MIAMI-DADE COUNTY  
DEPARTMENT OF TRANSPORTATION AND PUBLIC WORKS (DTPW)

ADDENDUM NO. 4  
April 25, 2022

PROJECT: Intersection Improvements to Old Cutler Rd. at SW 136 St. and SW 67 Ave.  
Project No. 20220017

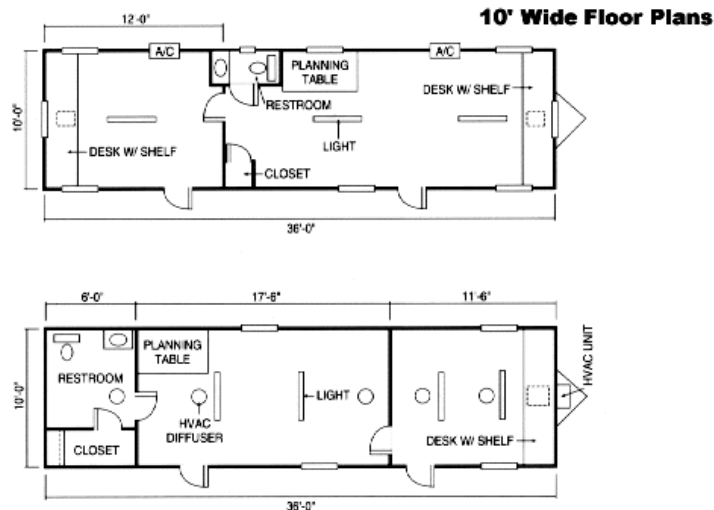
- a. Furnish and install one (1) new, factory manufactured, mobile field office unit not less than 10'X36'. Floor space shall be divided and shall include no less than one restroom and one private office. The private office shall be approximately 120 square feet. The Mobile Unit layout shall be consistent with either of the diagrams below. The private office will be located at an end of the mobile unit.
- b. Layout:
